ADDENDUM

NO. 1

PROJECT NAME: Tomball ISD Intermediate School Replacement

ADDENDUM DATE: Tuesday, July 28, 2026

1 PLUMBING PLAN - LEVEL 01 - AREA B
1/8" = 1'-0"

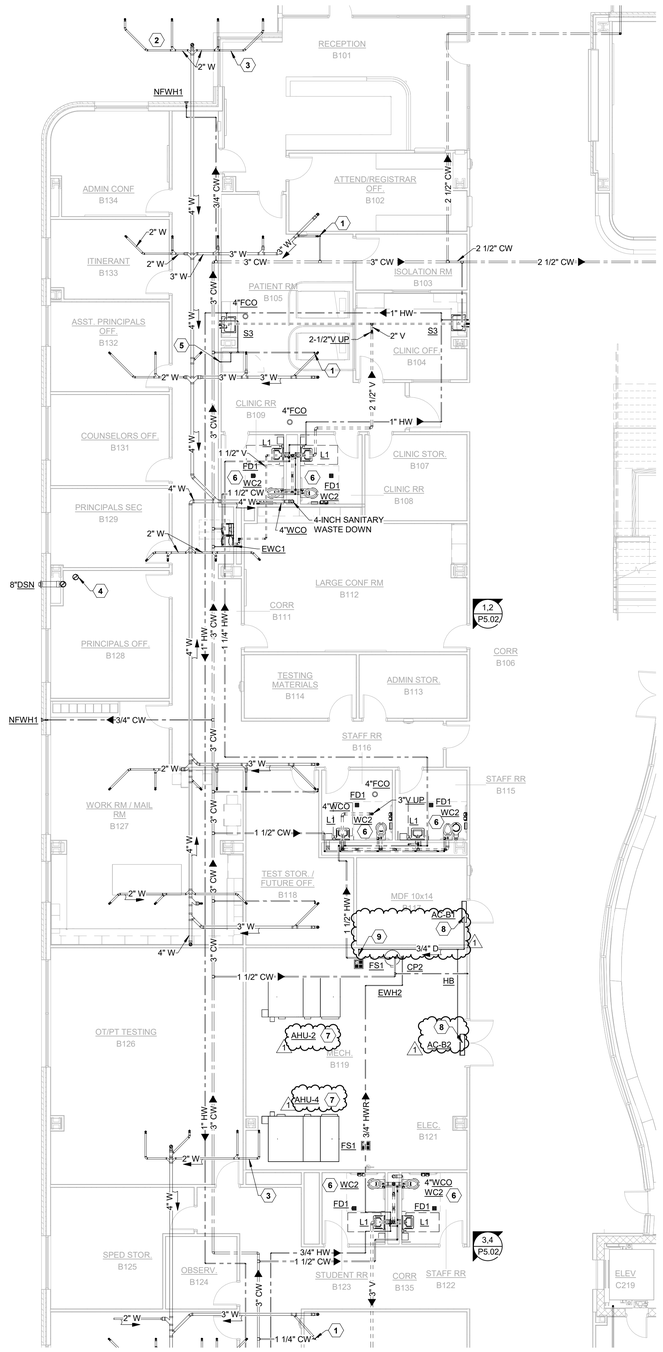
AD No 1, Plumb. Item 6: To the Drawings, Sheet P2.1B,"PLUMBING PLAN – LEVEL 01 – AREA B"

1 PLUMBING PLAN - LEVEL 02 - AREA A
1/8" = 1'-0"

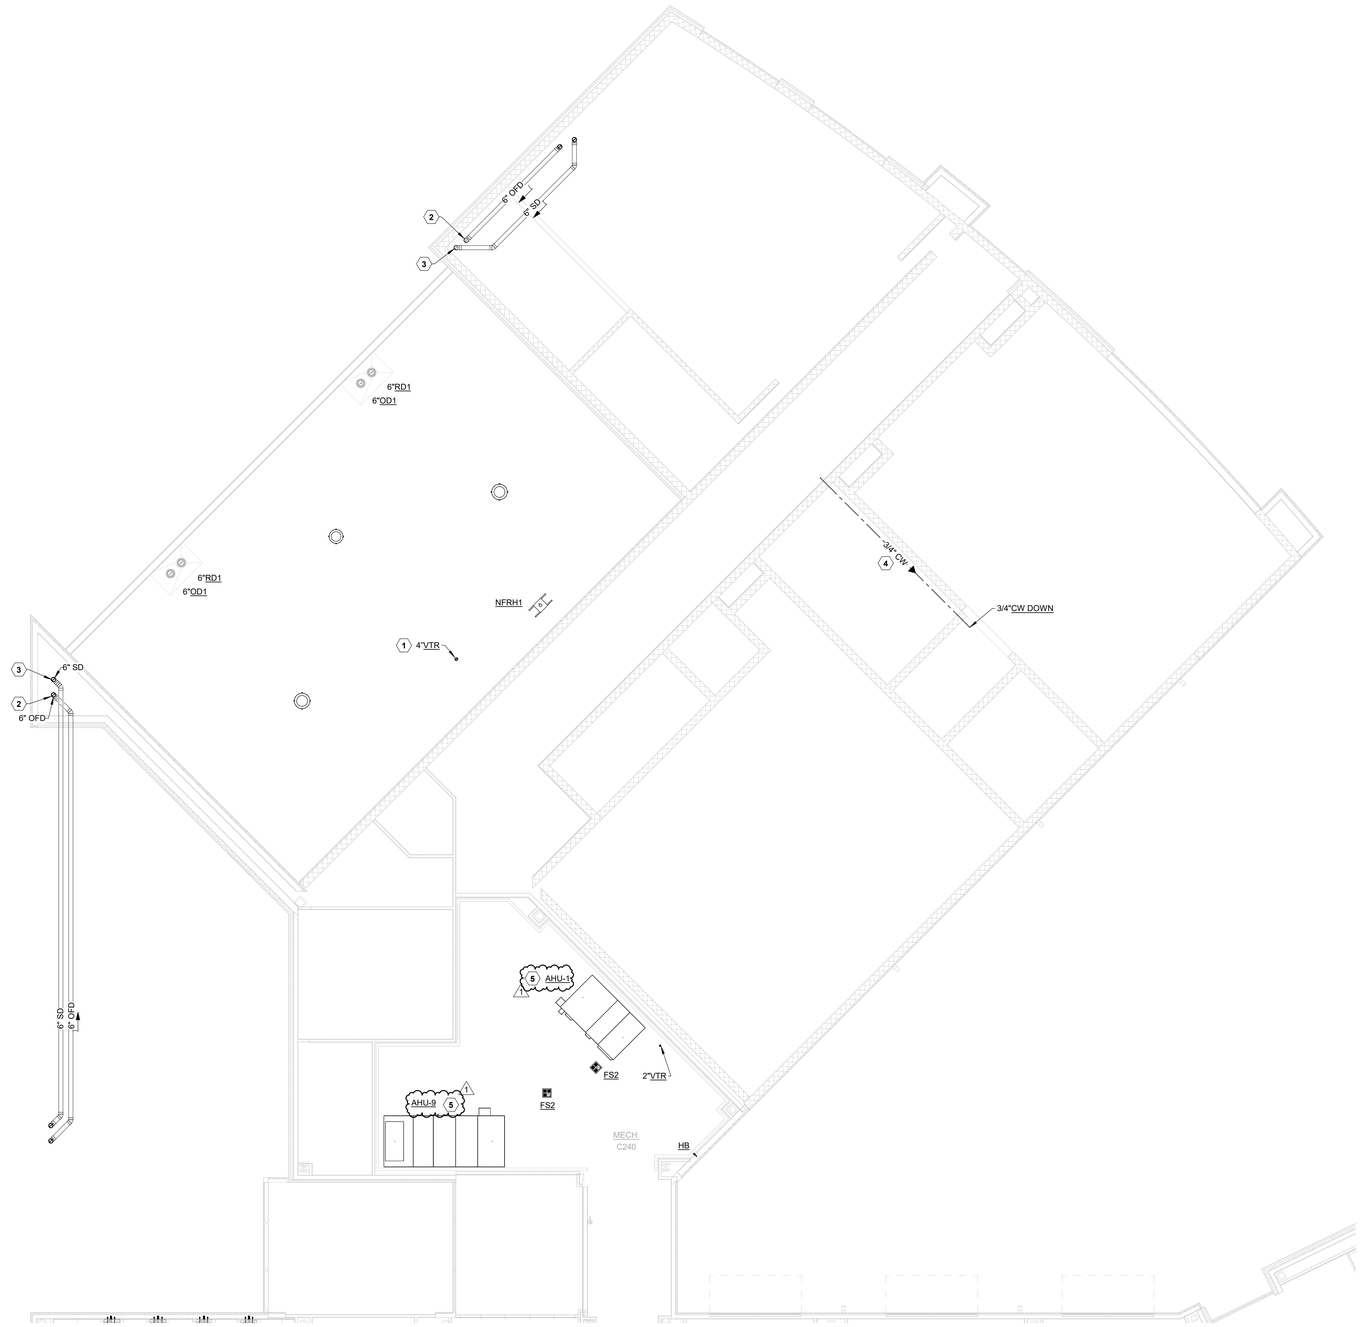
AD No 1, Plumb. Item 10: To the Drawings, Sheet P2.2A,"PLUMBING PLAN – LEVEL 02 – AREA A"

1) Added keynote 5.

1 PLUMBING PLAN - LEVEL 02 - AREA E
1/8" = 1'-0"

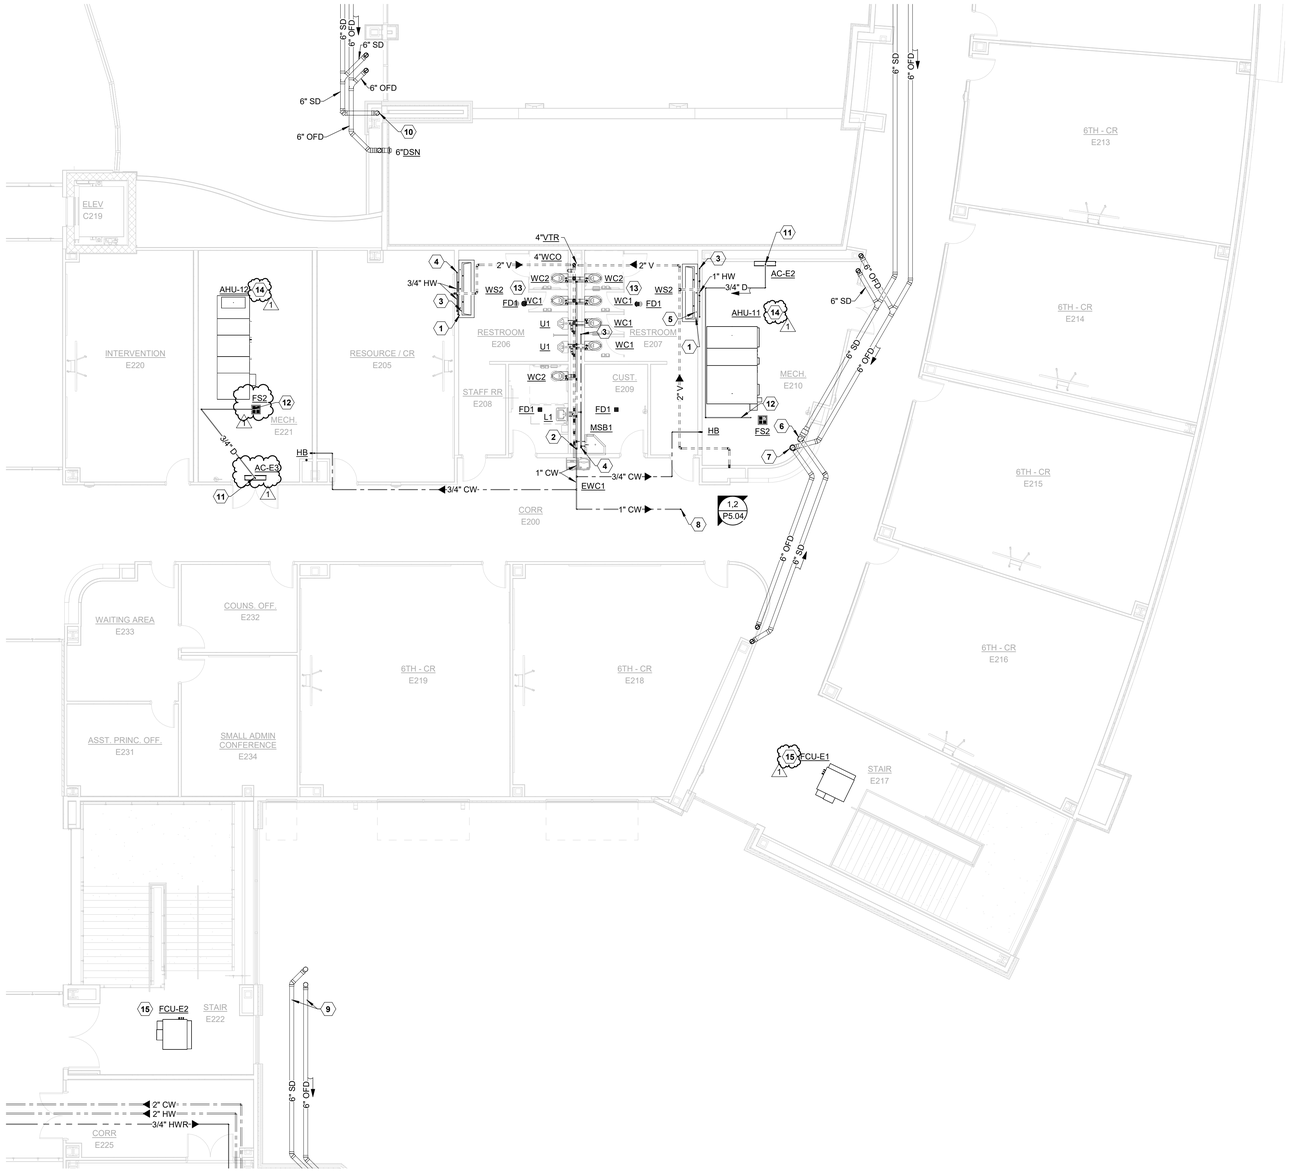
AD No 1, Plumb. Item 12: To the Drawings, Sheet P2.2E,"PLUMBING PLAN – LEVEL 02 – AREA E"

1 PLUMBING PLAN - LEVEL 02 - AREA F
1/8" = 1'-0"

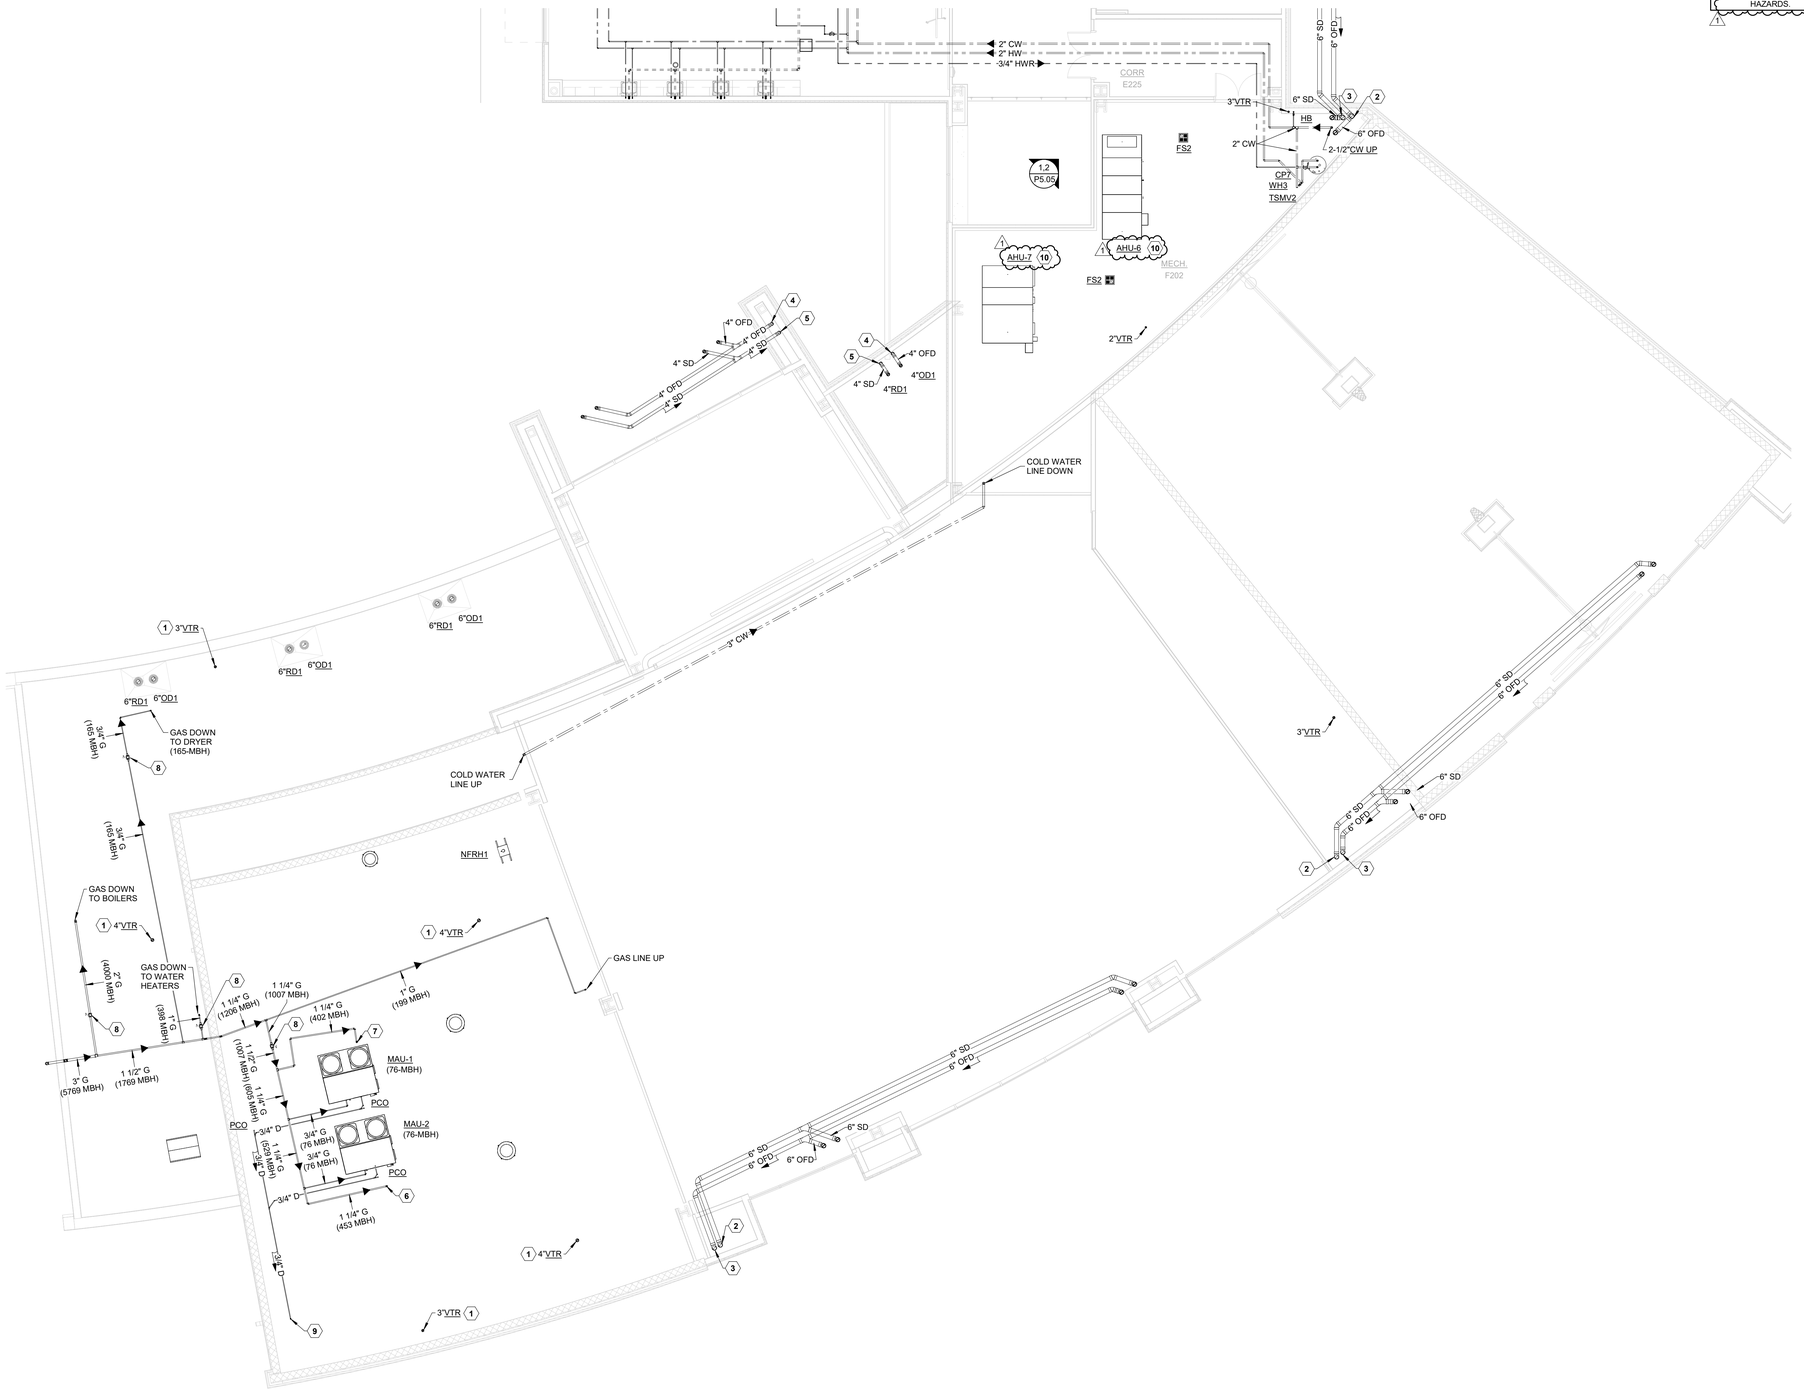
AD No 1, Plumb. Item 13: To the Drawings, Sheet P2.2F,"PLUMBING PLAN – LEVEL 02 – AREA F"

1 M2.1C — MECHANICAL PLAN - LEVEL 01 - AREA C
1/8" = 1'-0"

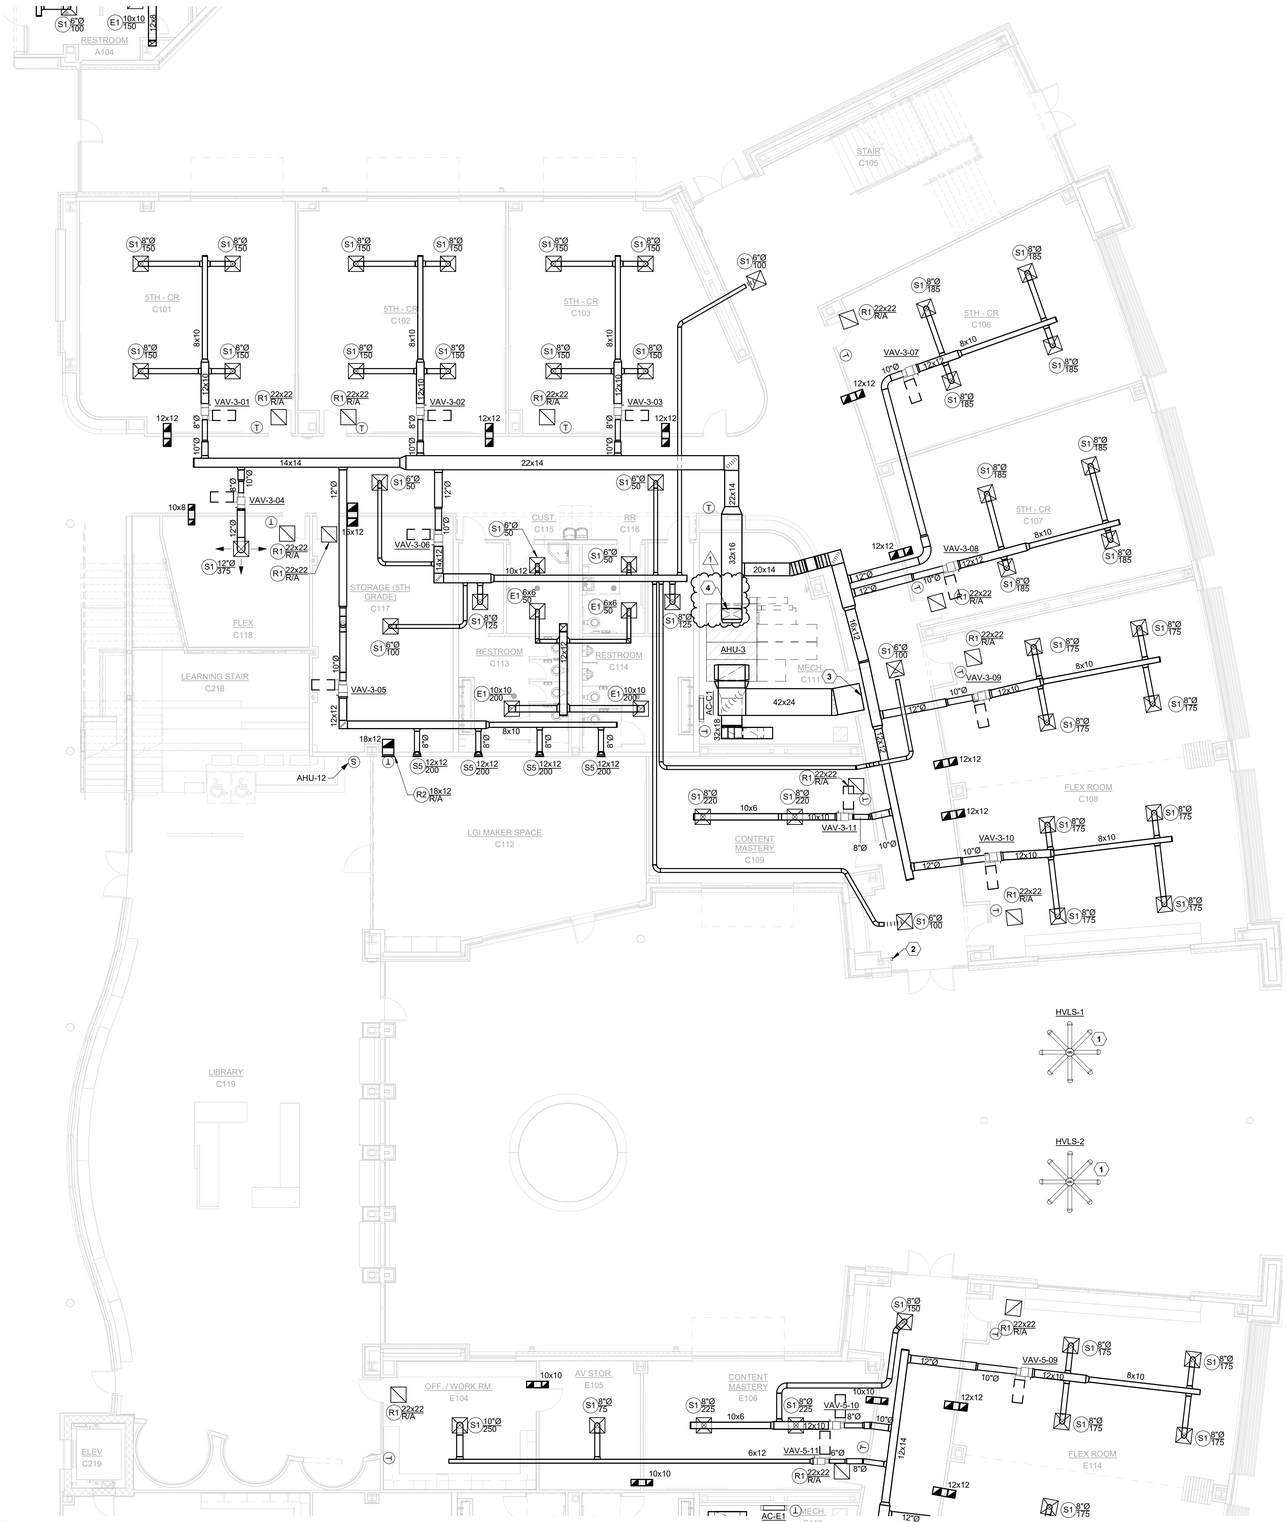
AD No 1, Mech. Item 2: To the Drawings, Sheet M2.1C, "MECHANICAL PLAN – LEVEL 1 – AREA C"

1 E1.00 ELECTRICAL POWER SITE PLAN
1" = 30'-0"

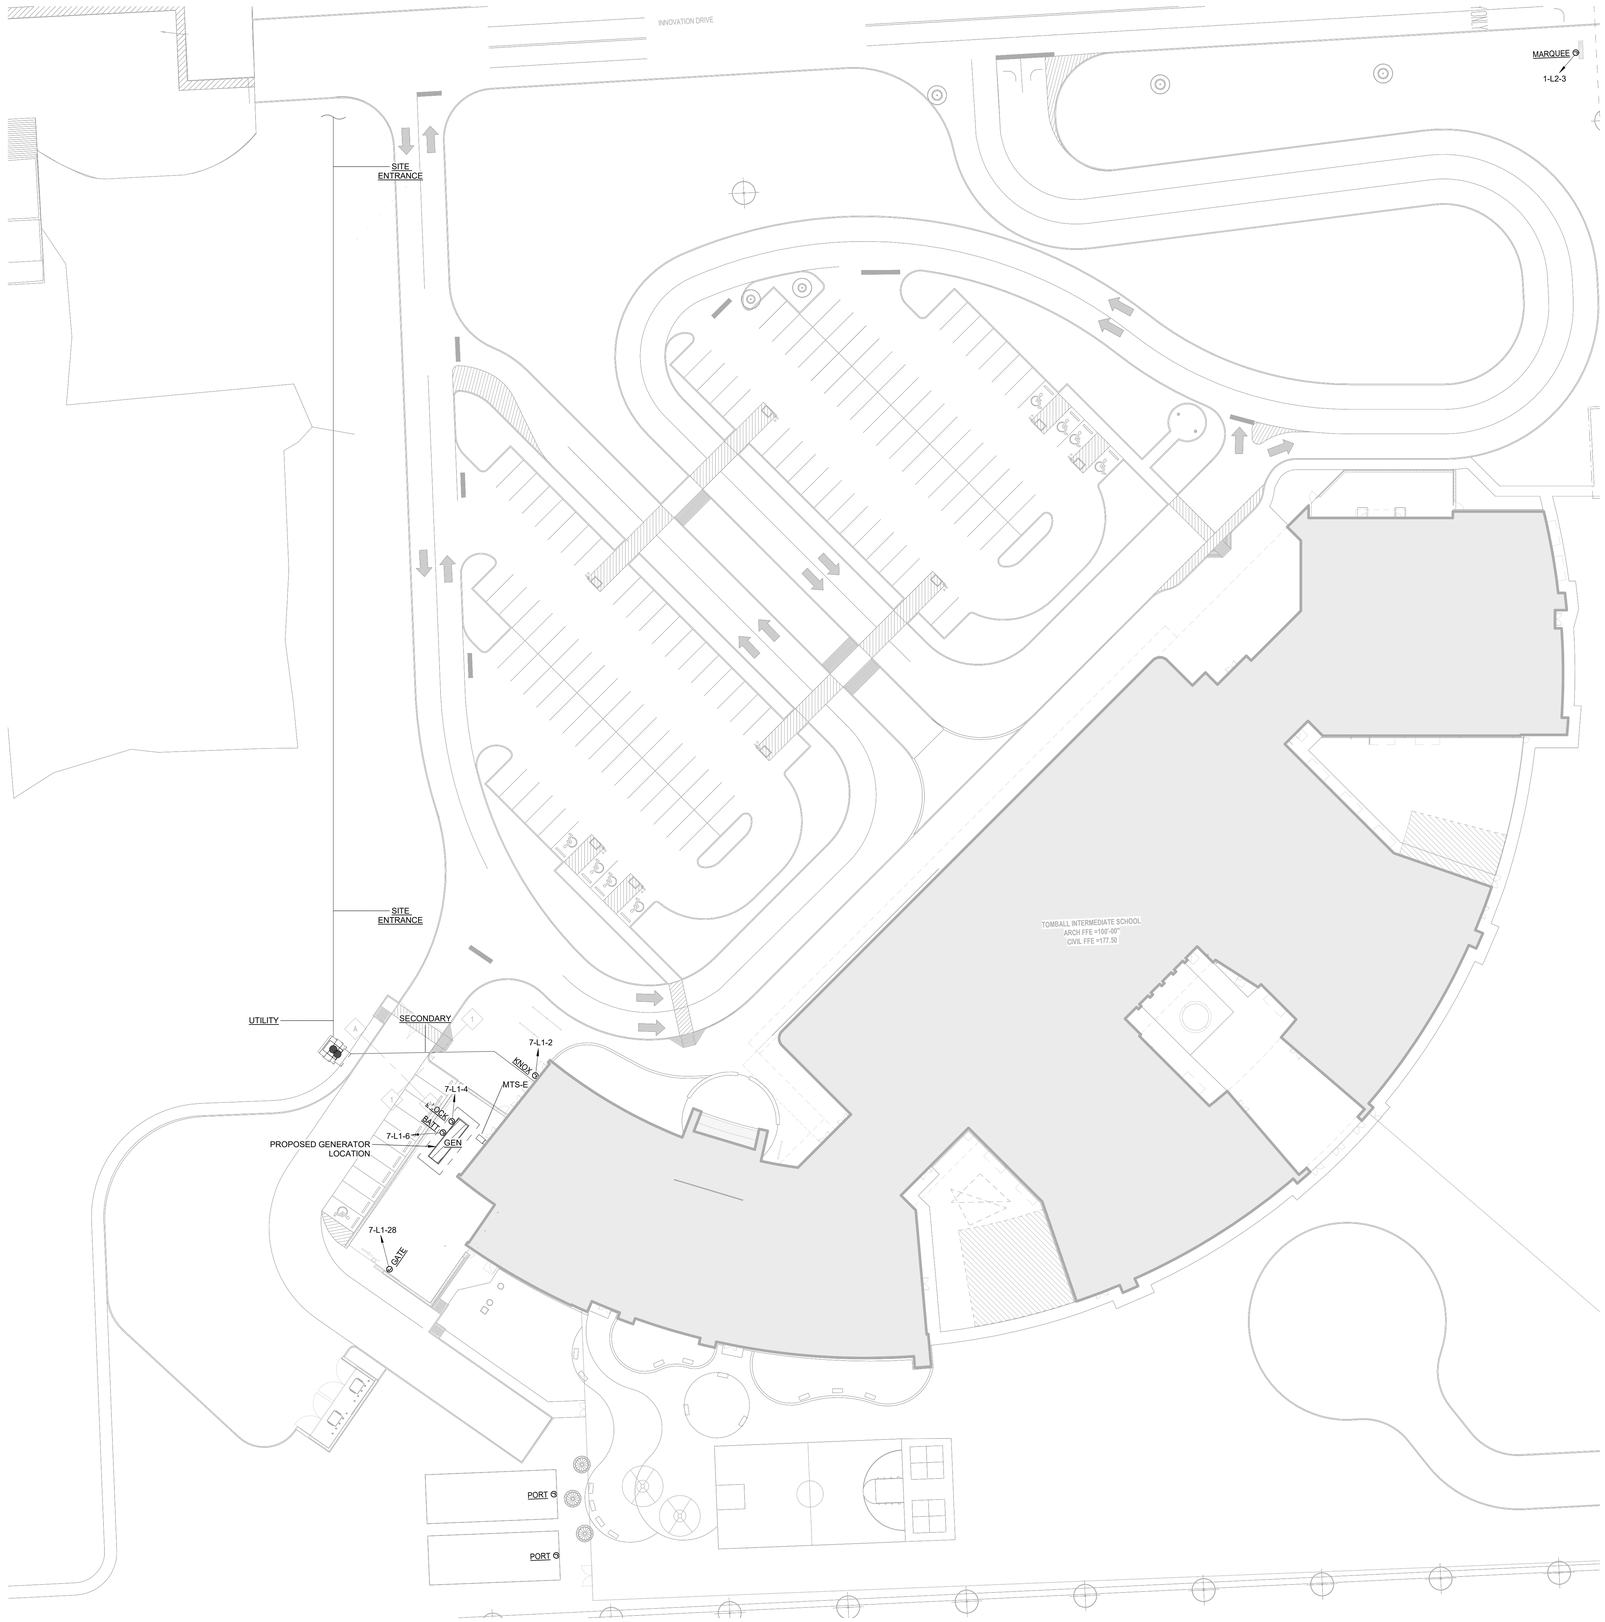
AD No 1, Elec. Item 2: To the Drawings, Sheet E1.00, "ELECTRICAL POWER SITE PLAN"
